Access Compliance Report

Public Rights-of-Way

(Curb Ramps)

Intersection ID: 6882	Main Street: STATESVILLE_RD	Cross Street: CINDY_LN	Location: NW
ADA ID: 3597ED26D164	Ramp Type: Para	Initial Pass/Fail: Pass	Overall Compliance: No
		Severity Score: 0

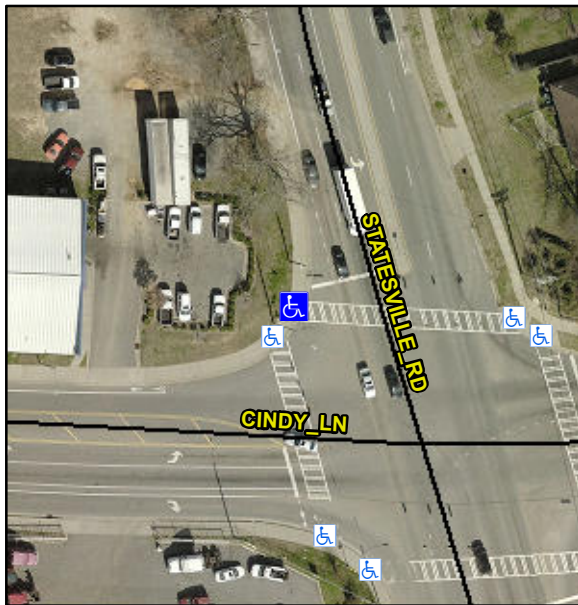
R305.2

Compliance	Description	Data	Compliance	Description	Data
N/A	Ramp Length LT (in)	59.0	N/A	Ramp Length RT (in)	74.5
Yes	Ramp Width LT (in)	84.0	Yes	Ramp Width RT (in)	84.0
Yes	Ramp Slope LT (%)	5.3	Yes	Ramp Slope RT (%)	7.9
Yes	Ramp XSlope LT (%)	1.9	Yes	Ramp XSlope RT (%)	0.6
Yes	Landing Length (in)	84.0	Yes	DWS Provided?	Yes
Yes	Landing Width (in)	48.0	Yes	DWS Contrast?	Yes
Yes	Landing Slope (%)	0.7	Yes	DWS Length (in)	24.0
Yes	Landing X Slope (%)	0.8	Yes	DWS Full Width?	Yes
N/A	Landing Curb? (Y/N)	No	No	DWS Offset (in)	3.5
N/A	Shared Landing?	No			
Yes	Gutter Ponding?	No	Yes	Gutter Slope (%)	4.5
Yes	Gutter Lip Ht (in)	0.0	Yes	Gutter X Slope (%)	1.4
N/A	Painted X Walk1?	Yes	N/A	Painted X Walk2?	N/A
	X Walk 1 Direction	To E		X Walk 2 Direction	N/A
N/A	X Walk 1 Width (in)	110.5	N/A	X Walk 2 Width (in)	N/A
	X Walk 1 Slope (%)	2.8		X Walk 2 Slope (%)	N/A
	X Walk 1 X Slope (%)	0.5		X Walk 2 X Slope (%)	N/A
Yes	Ramp inside XWalk1?	Yes	N/A	Ramp inside XWalk2?	N/A

Remove & Replace Detectable Warning System.
